**To:** Land Use and Planning Committee      **Date:** 7/12/2021

**From:** Emilie K Adin, MCIP      **File:** HER00810  
 Director of Development Services

**Subject:** 323 Regina Street: Heritage Revitalization Agreement - Preliminary Report

Figure 3: Proposed Site Plan

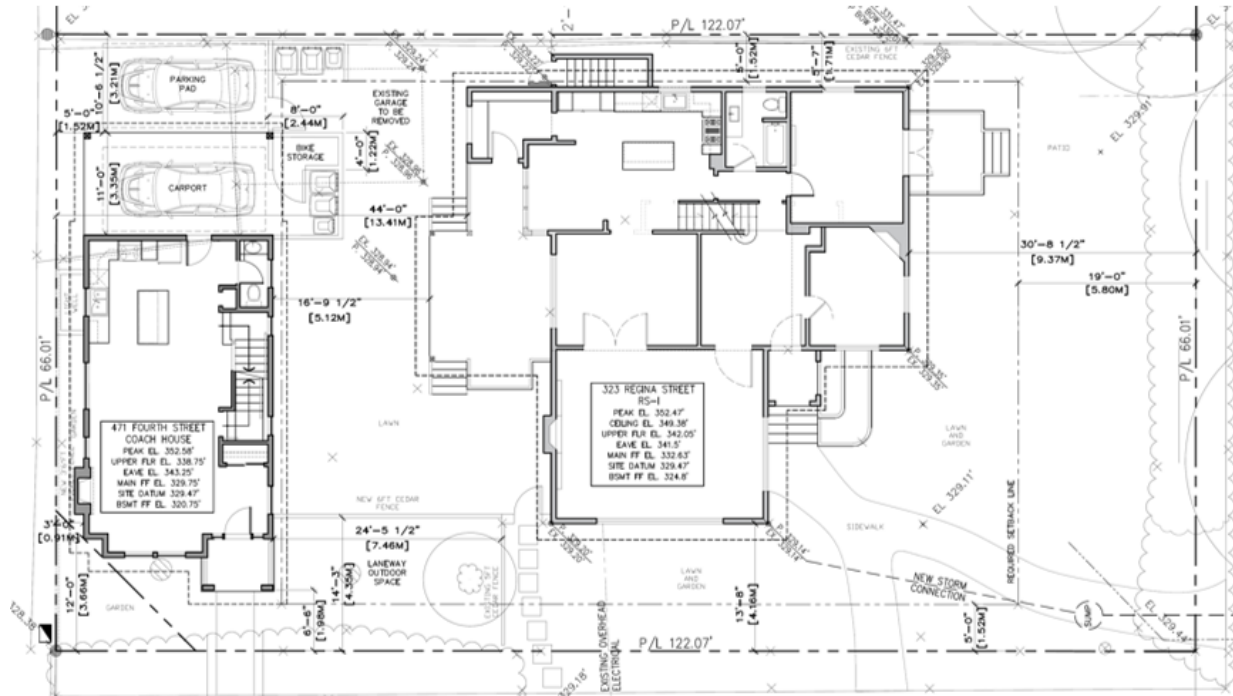
The heritage house has a density of 0.43 FSR and is 320 sq. m. (3,443 sq. ft.). The new house would have a density of 0.22 FSR and be approximately 162 sq. m. (1,747 sq. ft.). The total site density would be 0.65 FSR. Both houses would be family friendly sized where the heritage house has four bedrooms and the new house is proposed to have three bedrooms. The heritage house would remain in its current location and setback.

Figure 4: Proposed Fourth Street elevation provided by project team

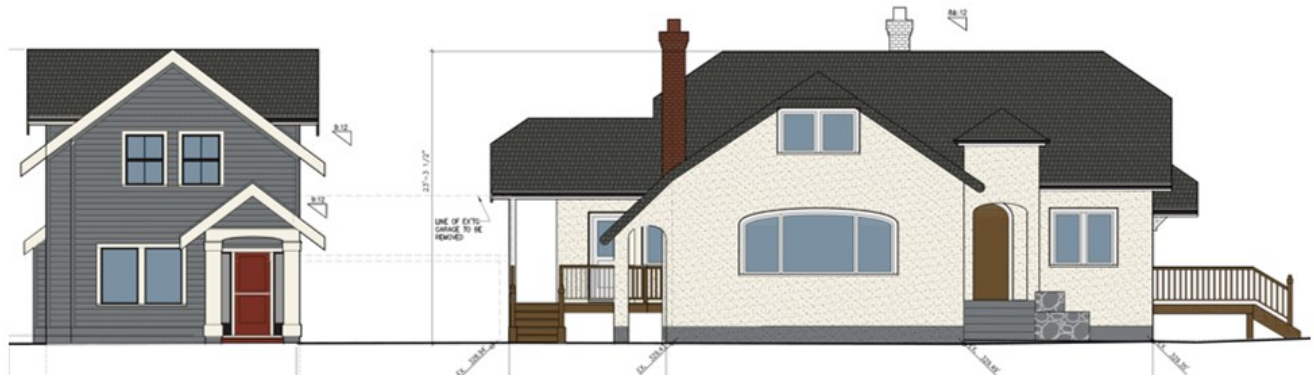
The design of the infill house (shown below and in Attachment 1) is consistent with the Queen's Park Heritage Conservation Area Design Guidelines and the Carriage House Development Permit Area Guidelines. Private open space and sufficient separation between the infill and the principal dwelling are provided, and light, privacy and overlook guidelines are generally followed. Secondary suites are not included as part of this application, but one could be added at a later date to the heritage house, subject to Council's approval, through an HRA amendment.

However, the size of the infill house (2.5 storeys) would be 55% larger than the maximum size for a carriage house in the Zoning Bylaw and under the Heritage Conservation Area's incentives program (max. 89 sq. m./958 sq. ft.). This is also larger than any carriage or laneway house HRA application to date.

The infill house could be made to be more consistent with the carriage house regulations and guidelines by reducing the size of the second story by 24 sq. m. (260 sq. ft.) and removing the basement space (entertainment room). This would also reduce building bulk and neighbour overlook.

*Does the Land Use and Planning Committee support that staff recommend the applicant reduce the size of the proposed infill house to be consistent with the carriage house design guidelines and the Queen's Park Heritage Conservation Area incentives program?*
